ADDENDUM # 1

November 5, 2021

**Bataan Lift Station Renovation
Bid No. 2021-09**

Bohannon Huston Inc.

BHI PROJECT NO.	20210255	DWG NO.	C-500R	SHEET OF	07 29
-----------------	----------	---------	--------	----------	-------

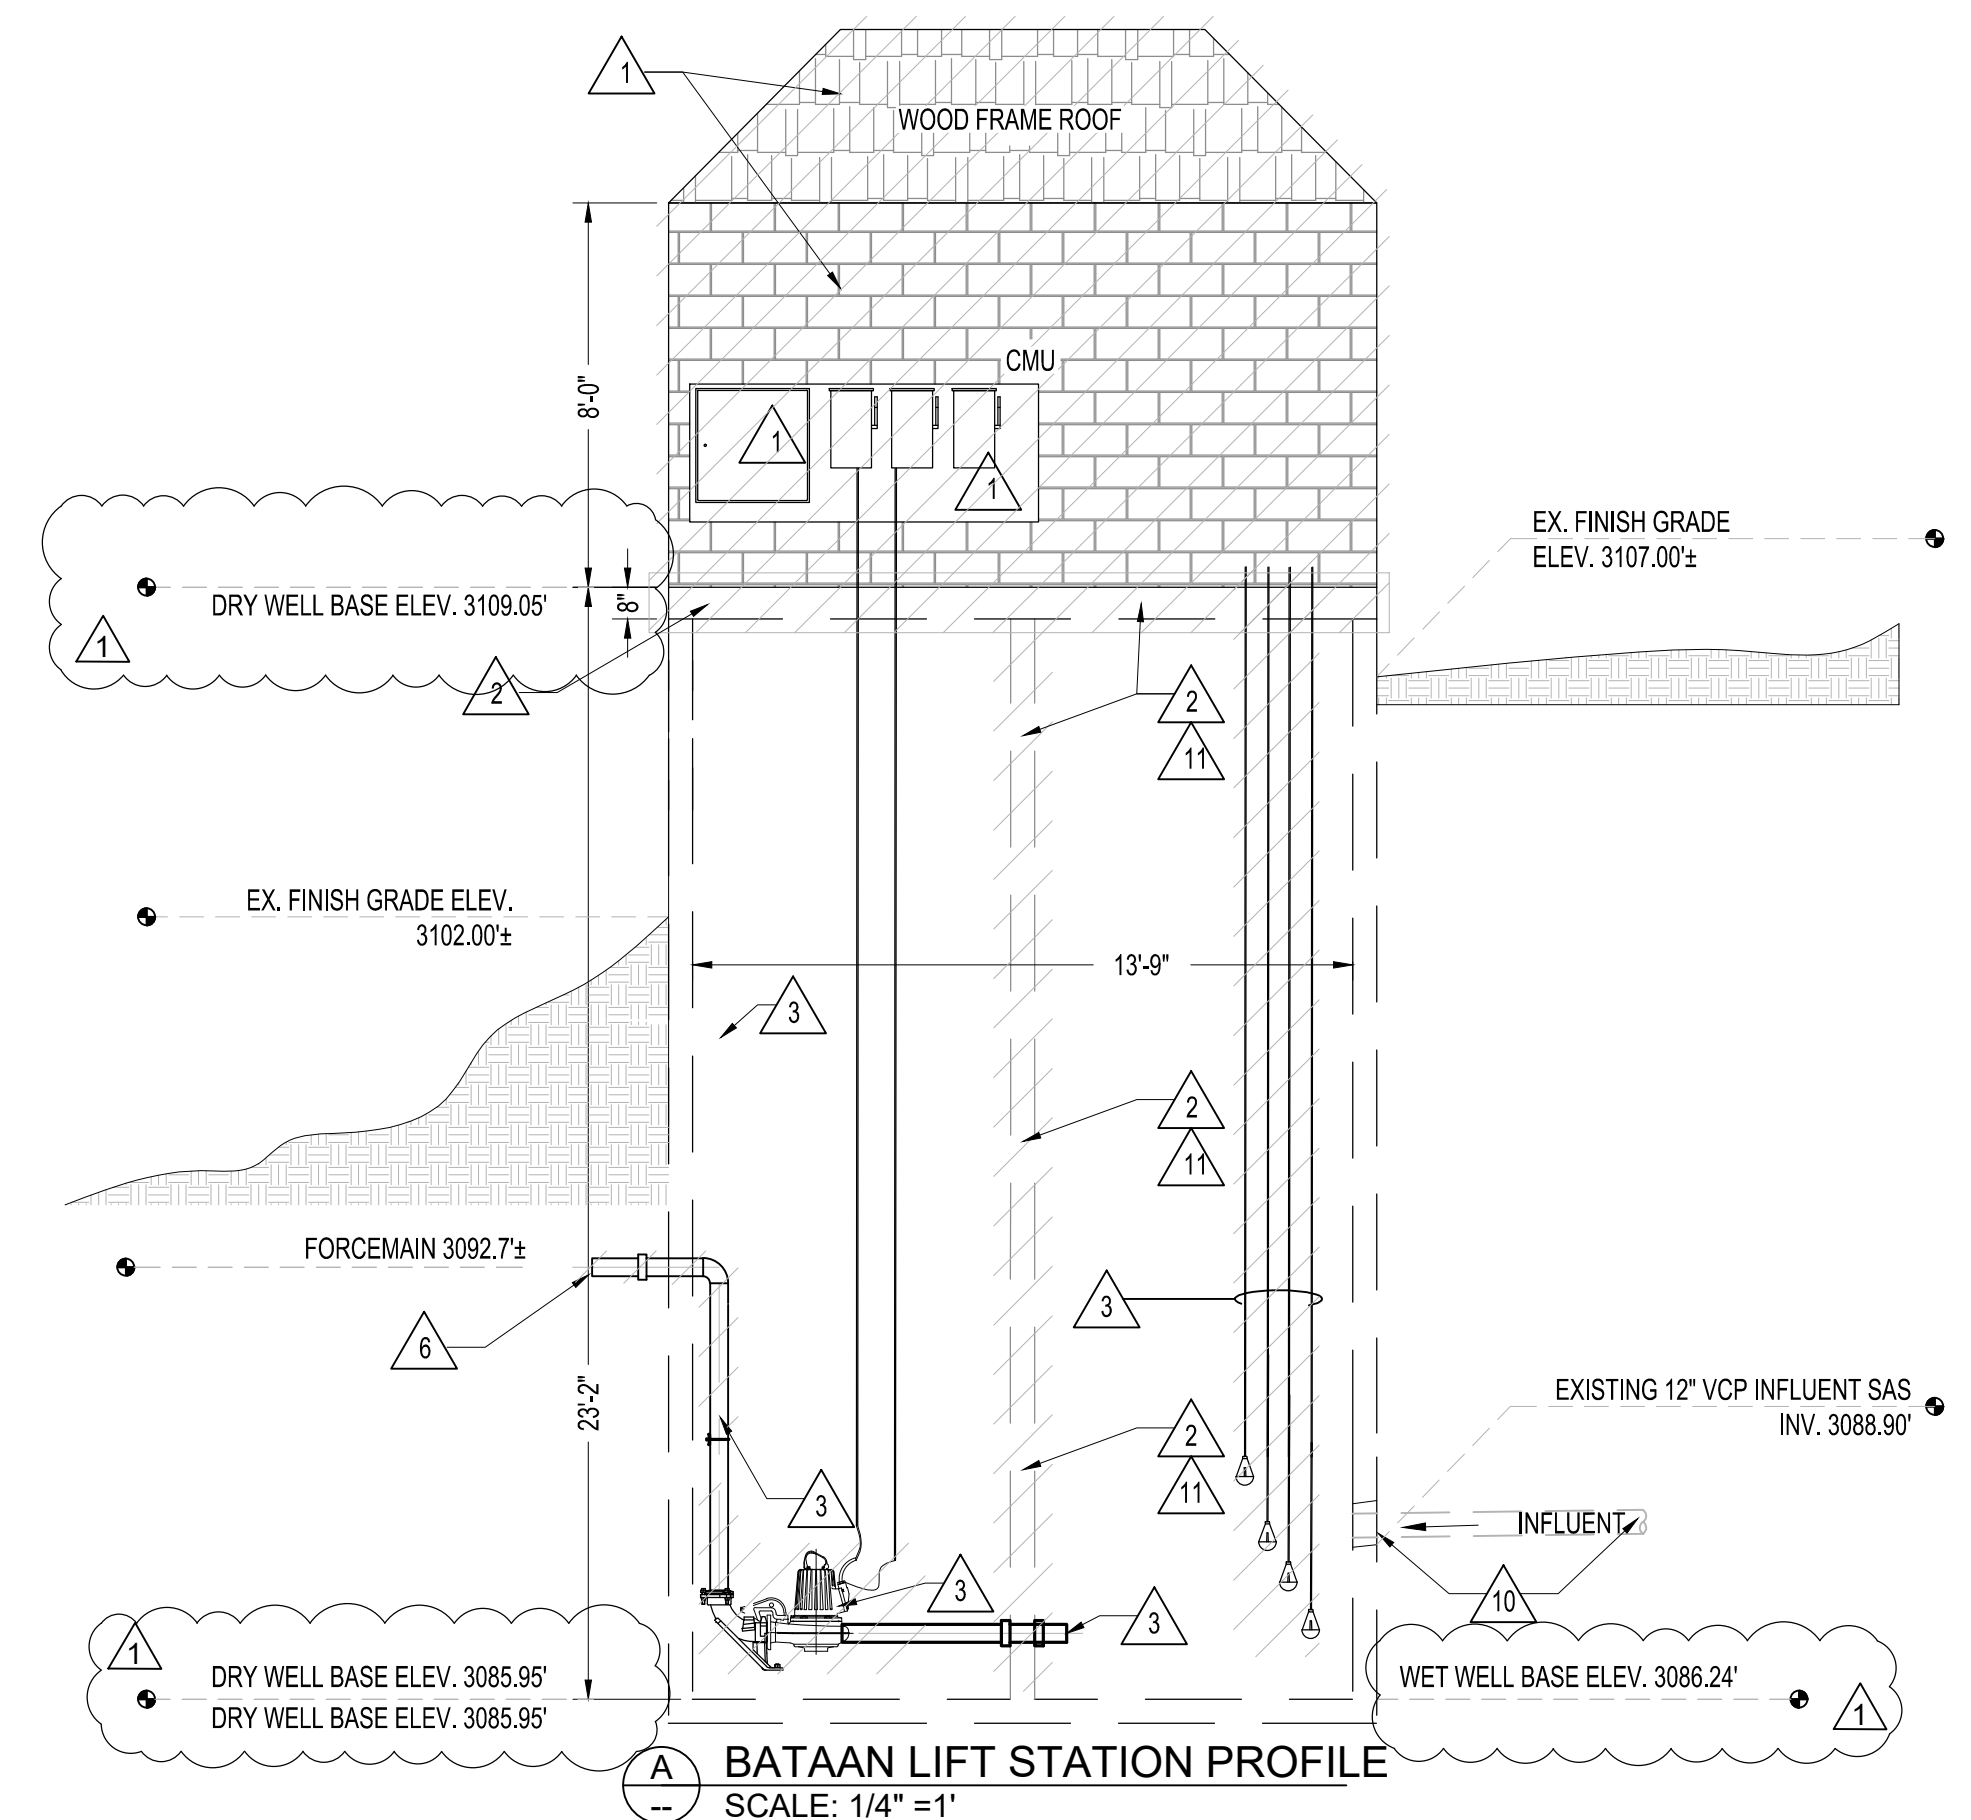
1. **Drawing C-500-R1**: Revised elevation data and corrected station depth dimensions.
2. **Drawing C-800-R1**: Revised elevation data.
3. **Drawing C-900-R1**: Revised elevation data and corrected station depth dimensions.

BHI PROJECT NO.	20210255	DWG NO.	C-800R	SHEET OF	10 29
-----------------	----------	---------	--------	----------	-------

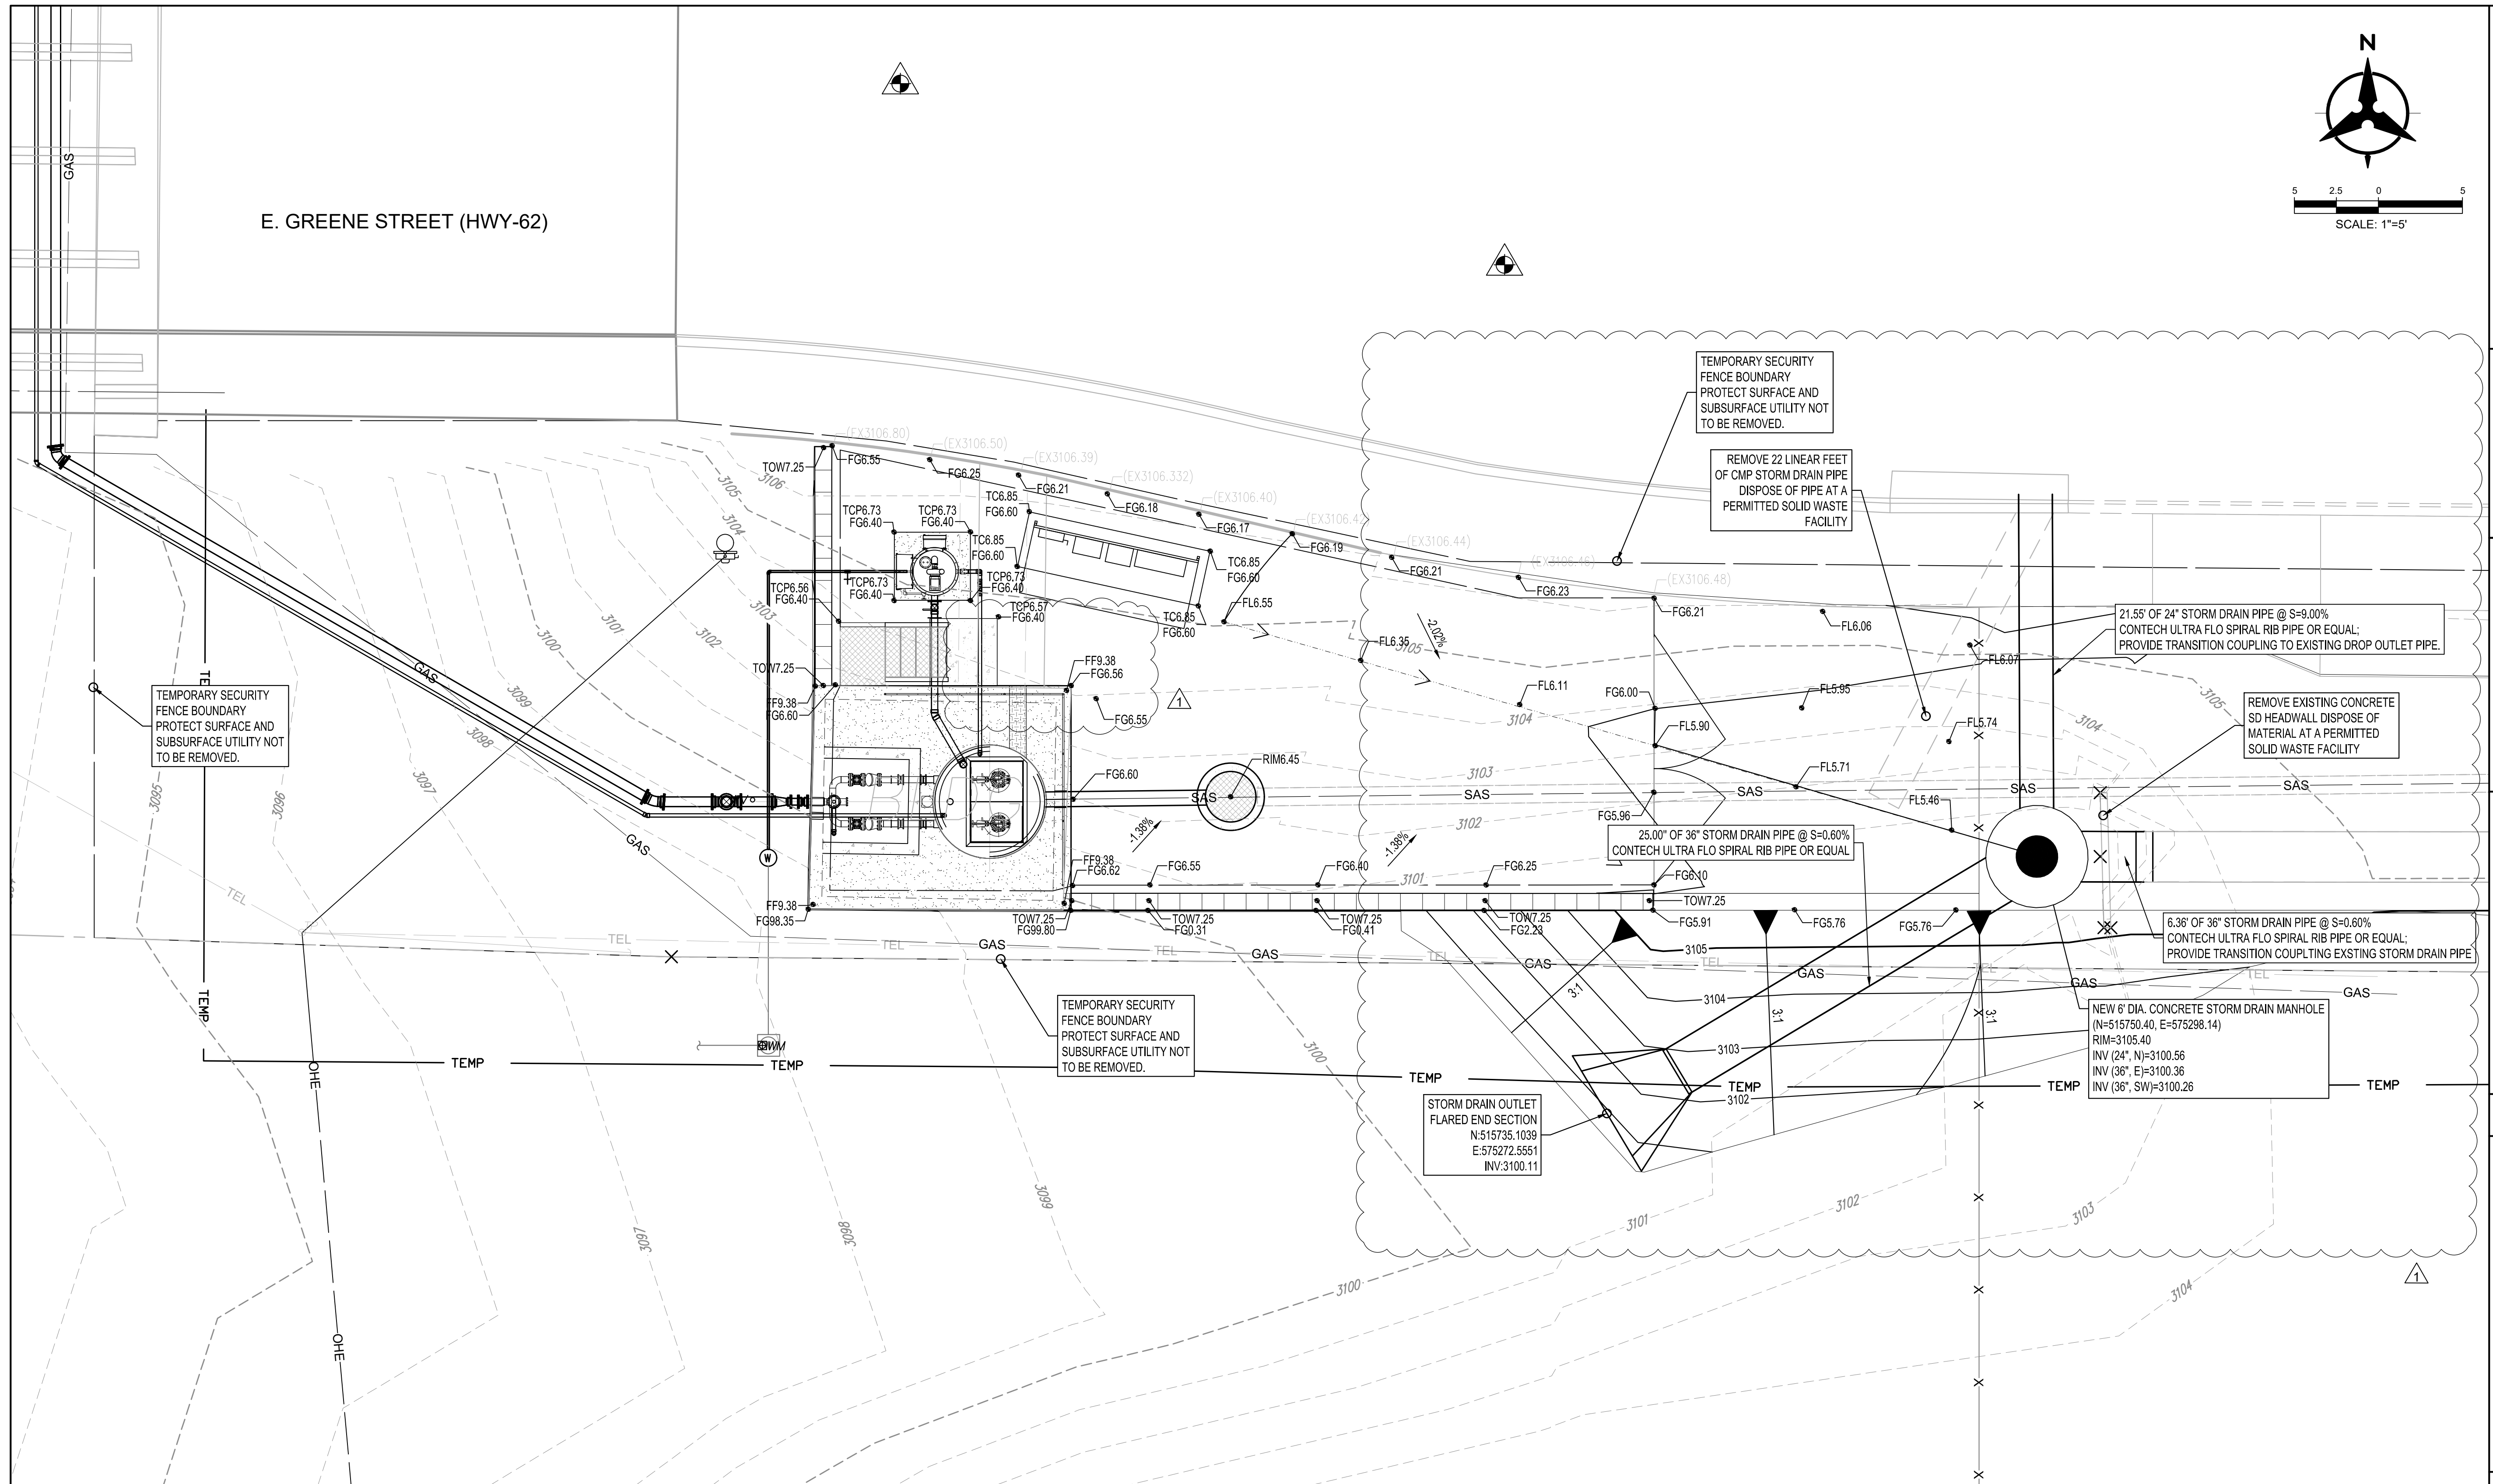
4. **Drawing C-1400-R1**: Revised manhole details and force main details.
5. **Drawing E-400-R1**: Deleted submersible cable junction box and associated raised concrete pad; Moved location of pole mount light fixture adjacent to southeast corner of wet well structure; Lengthened depth of shade structure; Revised keyed note 4.
